# Access Compliance Report

## Public Rights-of-Way

### (Curb Ramps)

Intersection ID: 28310	Main Street: ARDREY_KELL_RD	Cross Street: WADE_ARDREY_RD	Location: NW
ADA ID: AEC571471A31	Ramp Type: Perp	Initial Pass/Fail: Fail	Overall Compliance: No
Severity Score: 12.5			
Codes/Mitigation Info/Possible Solution		Field Measurements/Component Compliance

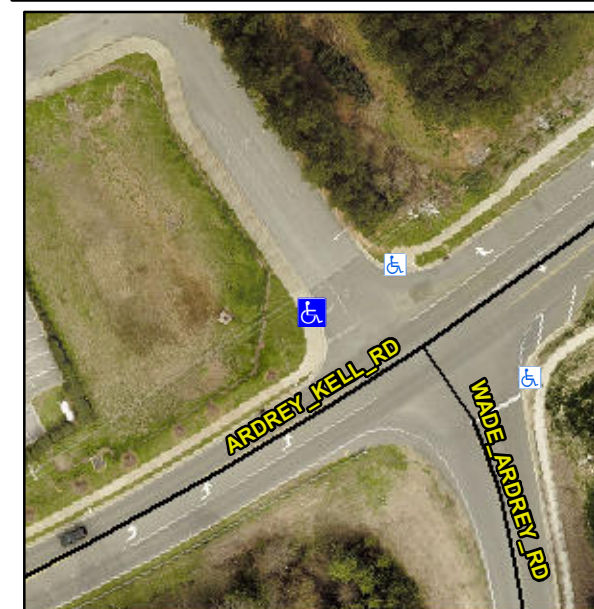
**Remove & Replace Entire Ramp.**

**R304.2.2**

Compliance	Description	Data	Compliance	Description	Data
N/A	Ramp Length (in)	36.0	No	Ramp Slope (%)	8.5
Yes	Ramp Width (in)	59.0	Yes	Ramp XSlope (%)	0.0
N/A	Flare Type LT	N/A	N/A	Flare Type RT	N/A
N/A	Flare Slope LT (%)	N/A	N/A	Flare Slope RT (%)	N/A
N/A	Flare Traversable LT?	N/A	N/A	Flare Traversable RT?	N/A
N/A	Landing Length (in)	N/A	N/A	DWS Provided?	N/A
N/A	Landing Width (in)	N/A	N/A	DWS Contrast?	N/A
N/A	Landing Slope (%)	N/A	N/A	DWS Length (in)	N/A
N/A	Landing X Slope (%)	N/A	N/A	DWS Full Width?	N/A
N/A	Landing Curb? (Y/N)	N/A	N/A	DWS Offset (in)	N/A
N/A	Shared Landing?	N/A			
N/A	Gutter Ponding?	N/A	N/A	Gutter Slope (%)	N/A
N/A	Gutter Lip Ht (in)	N/A	N/A	Gutter X Slope (%)	N/A
N/A	Painted X Walk1?	No	N/A	Painted X Walk2?	N/A
	X Walk 1 Direction	To NE		X Walk 2 Direction	N/A
N/A	X Walk 1 Width (in)	N/A	N/A	X Walk 2 Width (in)	N/A
	X Walk 1 Slope (%)	1.0		X Walk 2 Slope (%)	N/A
	X Walk 1 X Slope (%)	0.3		X Walk 2 X Slope (%)	N/A
